July 7, 2026

**EASTLAND COUNTY WATER SUPPLY DISTRICT (ECWSD)
WATER SYSTEM IMPROVEMENTS – CONTRACT K – FACILITY SUPPORT
TEXAS WATER DEVELOPMENT BOARD (TWDB) DWSRF PROJECT NO. 61928 (CID-11)**

Addendum No. 2

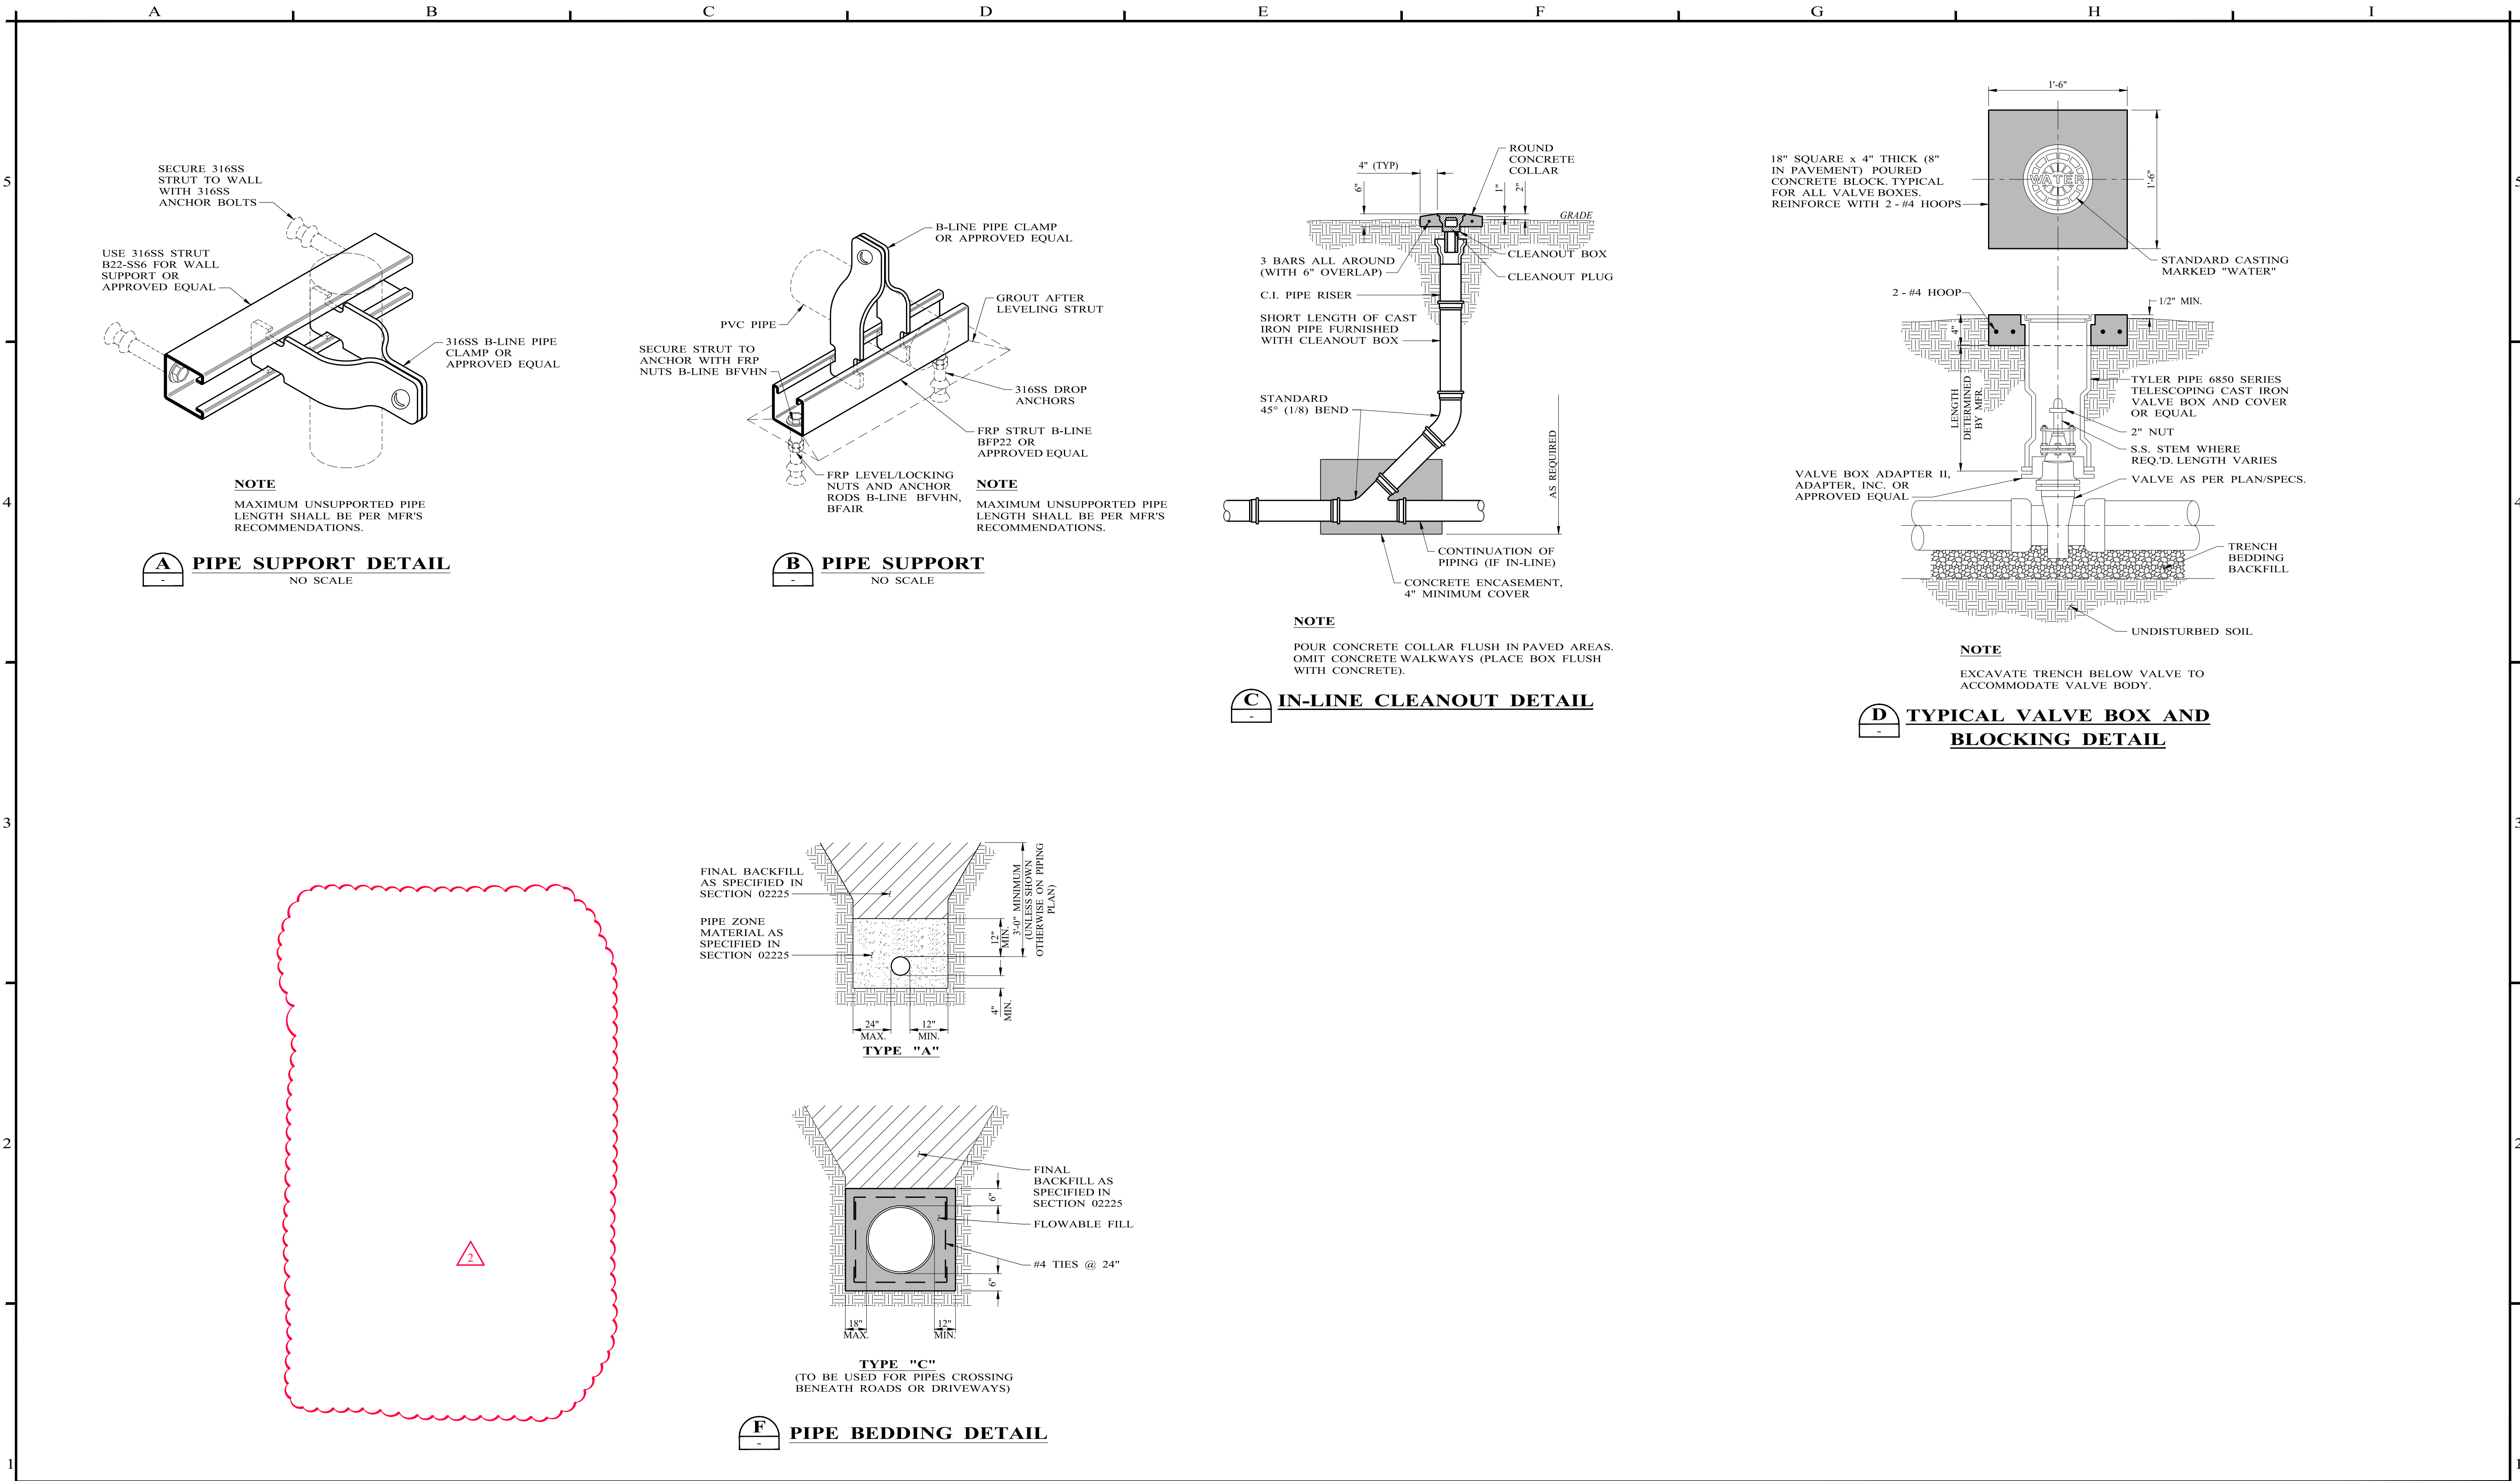
1. **DETAIL B** on **Sheet C-009** for a 4' Wide Man Gate to be **DELETED**.
2. **DETAIL E** on **Sheet C-007** and the **TYPICAL PIPE BOLLARD DETAIL** on **Sheet C-010** are for reference only.
3. The backfill for the plumbing lines will conform to **PIPE BEDDING DETAIL** on **Sheet C-007**.
4. **Sheet A-800 and Sheet A-803** have been updated to include the **Door and Hardware Schedule** Documents.
5. A **STUB-UP DETAIL** has been added to **Sheet A-805** for the (6) 1" plumbing stub-ups under the ab sink for future sample locations within the plant.
6. The automatic gate is to replace the existing automatic gate at the perimeter fence as shown on **Sheet C-003** and not at the building as shown on **Sheet E-2**.
7. Road shall follow **DETAIL D** on **SHEET C-008**.
